Appl. No. 10/618,187
Amdt. dated February 1, 2008
Amendment under 37 CFR 1.116 Expedited Procedure
Examining Group 1763

Amendment(s) to the Drawings:

REMARKS/ARGUMENTS

FIG. 7

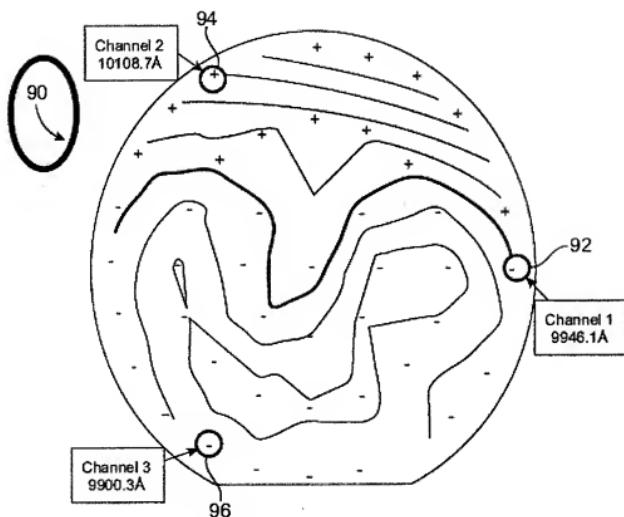
In an office action mailed October 1, 2007 (hereinafter "Office Action"), the Examiner objected to the drawings, including Fig. 7, for failing to comply with 37 CFR 1.84(p)(5), as not including that reference sign 90 mentioned in the description. Accordingly, Applicants submit a replacement drawing to correct this informality. [Office Action, page 2] As this reference sign was included in the application as originally filed on July 10, 2003 (hereinafter "Application"), no new matter has been introduced.

The attached sheet of drawings includes changes to Fig. 7. This sheet, which includes Fig. 7, replaces the original sheet including Fig. 7.
